Addendum 01 to Report LRG-CDL-ZZ-XX-T-AS-45260

Project 123 Levenshulme Road	Project No. 1046729	Date 05/08/2025
Purpose of note Report Addendum	Document No. LRG-CDL-ZZ-XX-T-AS-45260-ADD01	Revision P01
Prepared by Neil Bodsworth

This document is a technical addendum to the Internal Noise Level Commissioning Report, reference LRG-CDL-ZZ-XX-T-AS-45260, issued on 10 July 2025.

Figure 5-1: Noise mitigation to Plot 1 MVHR unit

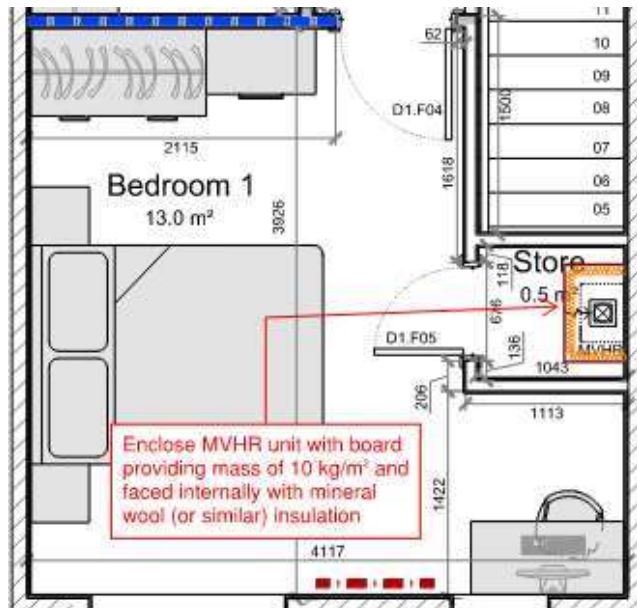
A secondary enclosure, as indicated below in Figure 5-1, formed of a single layer of plasterboard, plywood, MDF or similar, with a mass of at least 10 kg/m² and lined internally (facing the MVHR unit) with a 25mm tissue faced mineral wool or foam material, would reduce the noise levels within the cupboard space by at least 3 dBA.

Figure 2-1, right, indicates the duct connections off the top of the MVHR unit being completely boxed-in with additional mineral wool insulation packed around the sides and top of the MVHR unit (which will then be boxed-in as per the ductwork above, leaving the main face and bottom of the MVHR unit exposed for access and maintenance).

The mitigation measures applied, even prior to final boxing-out, has resulted in the MVHR unit noise level reducing by 6 dB within the utility cupboard.

Observations on site during these repeat tests have identified that the dominant source of the MVHR unit noise emissions is emitted from the back sides of the unit. The acoustically absorbent mineral wool insulation lagging the sides of the MVHR unit and packed up the rear wall of the cupboard provide a significant reduction to these noise emitting elements of the MVHR unit.

Further reductions to the noise levels inside the utility cupboard are anticipated once the mineral wool insulation is boxed-in with a suitable lining, however, it is deemed that the insulation alone has provided sufficient noise mitigation and the linings will no longer need to meet the minimum mass requirements specified in the original report.

As per the original report, the mitigation measures that have been applied within Plot 1 shall be replicated in Plots 2, 3, and 6.

Figure 5-2: Noise mitigation to Plot 20 MVHR unit

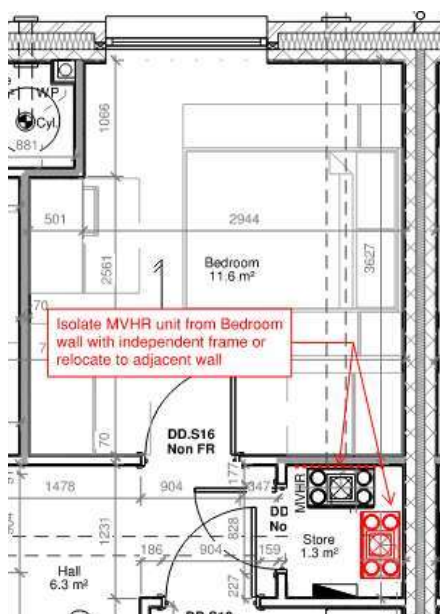
It is therefore recommended that the MVHR unit is structurally isolated from the partition with the Bedroom. This could either be achieved by means of an independent frame fixed to the floor/ceiling of the store room, or by relocating the MVHR unit to the adjacent wall of the store room, as indicated in Figure 5-2, below.

Eliminating the structure-borne noise component from the MVHR unit is expected to result in a noticeable reduction to the ambient noise level in the Bedroom

Due to the duct routings, it was not practical to relocate the MVHR unit to a different wall.

Figure 3-1: Plot 20 Mitigation measures

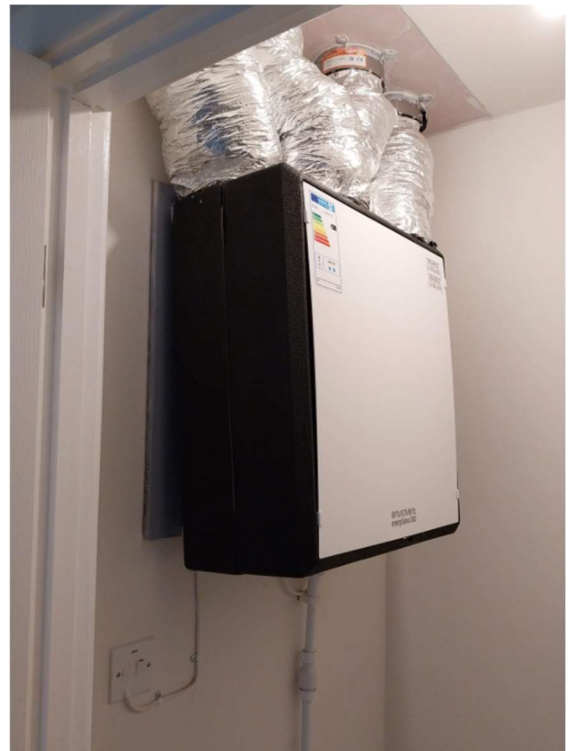
Instead, Figure 3-1, right, shows an additional layer of dense plasterboard mounted between the MVHR unit and the internal bedroom wall – the upper bracket supporting the MVHR unit (not visible in photo) includes rubber furring's and is fixed to this additional board.

The MVHR unit is hung from the upper bracket, peg mounts at the bottom of the MVHR space the unit away from the wall but are not mechanically fixed.

The measured noise levels inside the bedroom, following the mitigation measures shown above, did not demonstrate any significant change (< 1.0 dB) to the noise levels measured prior to the works being undertaken.

Additional observations carried out during the site visit have identified that the noise levels transmitting into the Bedroom of Plot 20 are actually more influenced by direct airborne sound transmission through the internal wall than structure-borne noise as originally anticipated.

To mitigate the MVHR noise levels in the Bedroom, it will therefore be necessary to reduce the noise level within the storeroom in which the MVHR unit is located.

The mitigation measures undertaken in Plot 1 have demonstrated that a significant reduction to the noise levels within the utility cupboards can be achieved through the inclusion of acoustically absorbent insulation lagging the rear sides of the MVHR unit.

Similar insulation measures shall therefore be undertaken to those in Plot 1.

If, due to the relative position of the MVHR unit to the storeroom door, it will not be feasible to utilise mineral wool insulation with associated boxing-in, an alternative acoustic insulation product can be considered that is more robust and would not require additional linings/encasement.

A Class O open cell acoustic foam could be applied to the rear wall of the storeroom, behind and around the MVHR unit. Provided the foam insulation product is thick enough to overlap the sides of the unit around its edges, it should provide a similar performance to the mineral wool insulation installed in Plot 1.

Based on the measured noise level change in Plot 1, the application of similar mitigation measures in Plot 20 are expected to reduce the internal ambient noise levels in the Bedroom by at least 2 dB which would then be compliant with the MCC internal noise limits.

As per the original report, the mitigation measures to be applied within Plot 20 shall be replicated in Plots 9, 10, 25, 14, 15, 29, 21, and 34.
